**PLANNED UNIT DEVELOPMENT
& SUBDIVISION STAFF REPORT****Date: November 7, 2013****DEVELOPMENT NAME**

Volunteers of America

Harris Place Subdivision, Resubdivision of Lot 1

1000 Farnell Lane

SITE PLAN

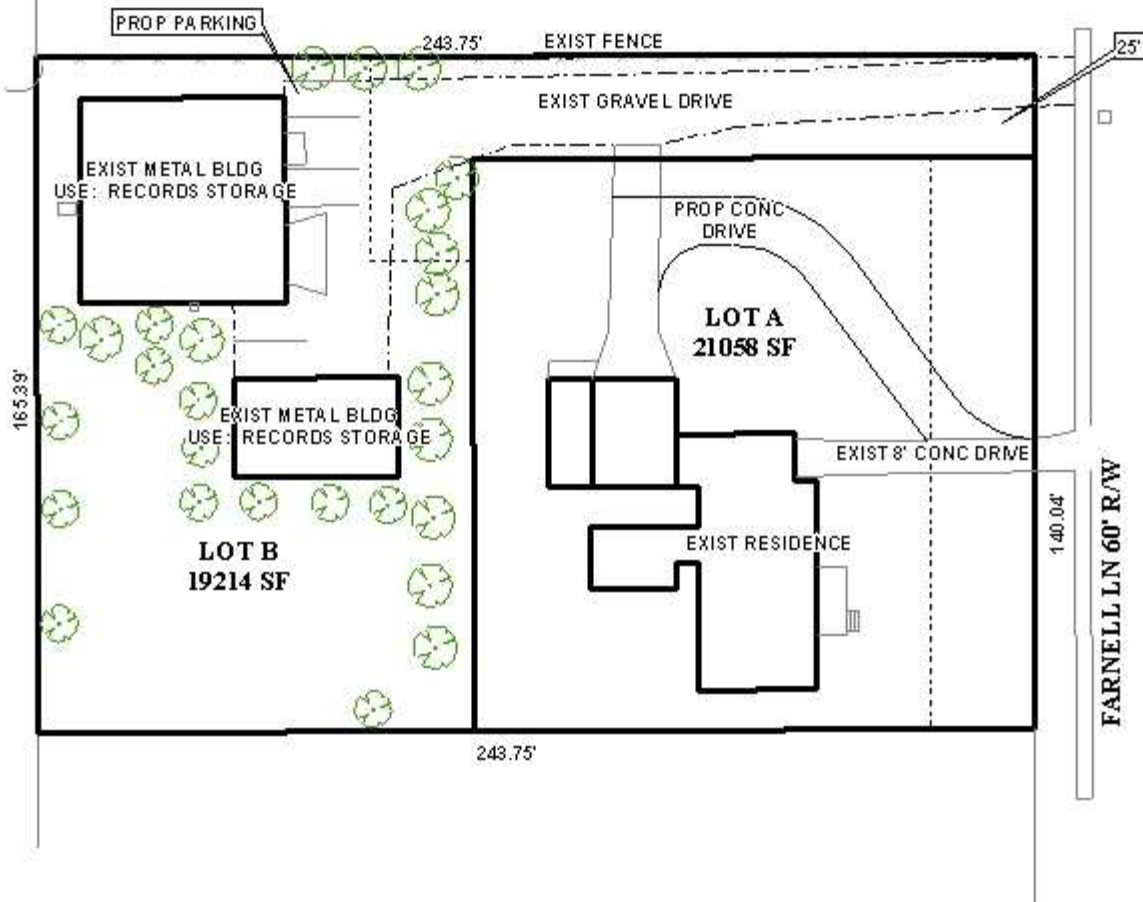
Revised for the November 7th meeting: “1. Add a note to the PUD drawing stating that any work performed in the existing ROW (right-of-way) such as grading, drainage, driveways, sidewalks, utility connections, irrigation, or landscaping will require a ROW permit from the City of Mobile Engineering Department (208-6070) and must comply with the City of Mobile Right-of-Way Construction and Administration Ordinance (Mobile City Code, Chapter 57, Article VIII). 2. Add a note to the PUD drawing stating that a Land Disturbance Permit will be required for any site improvements on the property. These improvements may require storm water detention. The Permit submittal shall be in accordance with the Storm Water Management and Flood Control Ordinance (Mobile City Code, Chapter 17, Ordinance #65-007 & #65-045). 3. Add a note to the PUD drawing stating that any existing or proposed dumpster pad(s) must be designed to collect storm water in a separate surface drain that is connected to the Sanitary Sewer system. 4. Add a note to the PUD drawing stating that any work performed within this development must comply with all Engineering Department Policy Letters.”

The site plan depicts four parking spaces for the proposed lot B which will serve as a storage building for records for Volunteers of America. Revisions should be made to the parking configuration to eliminate one parking space due to limited maneuvering area on site. Three parking spaces with bumper stops and maneuvering space should be provided to allow adequate room between the two buildings.

- 2) *provision of only three parking spaces with bumper stops on lot B;*
- 3) *submission of a revised PUD site plan to the Planning Section of Urban Development prior to the signing of the Final Plat;*
